Introduction

New text for HARQ support

8.4.9.5 Chase Combining HARQ (optional)

Modifications from text in 802.16RevD/D5

Figure 255—Creation of the OFDMA randomizer initialization vector for H-ARQ

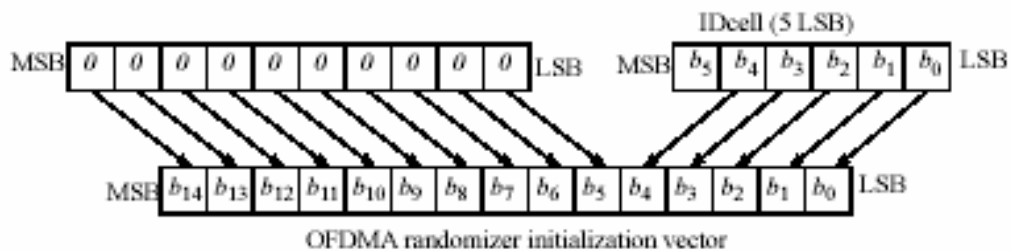
The method for randomizing the data must be modified to accommodate the Chase combining. Currently, the PRBS generator is seeded based on the starting OFDM symbol number and subchannel number. This can result in a different randomization pattern for each HARQ attempt making them impossible to combine. To remedy this problem, it proposed that the PRBS be seeded with the cell ID as is done for the CTC IR.

Insert the following text at the end of section 8.4.9.1 randomization

H-ARQ requires that the randomizer pattern be identical for each H-ARQ attempt. For H-ARQ operation, the randomizer shall be initialized with the with the vector created as shown in Figure 255.

Figure 130—Construction of H-ARQ encoder packet

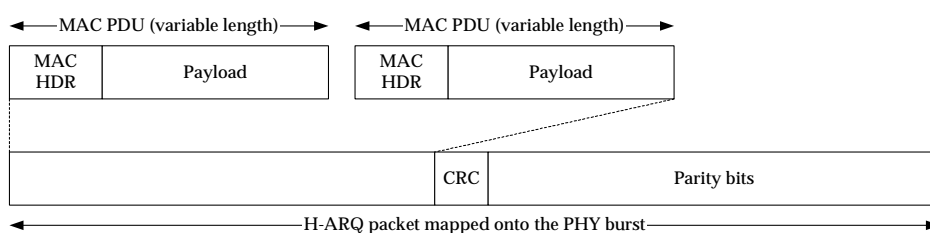
Modify Section 6.3.17 "MAC support for HARQ" after figure 130

The two main variants of H-ARQ are supported, Chase Combining or Incremental Redundancy (IR). For IR, the PHY layer will encode the H-ARQ packet generating several versions of encoded subpackets. Each subpacket will be uniquely identified using a subpacket identifier (SPID). For Chase Combining, the PHY layer will encode the H-ARQ packet generating only one version of the encoded packet. As a result, no SPID is required for Chase Combining.
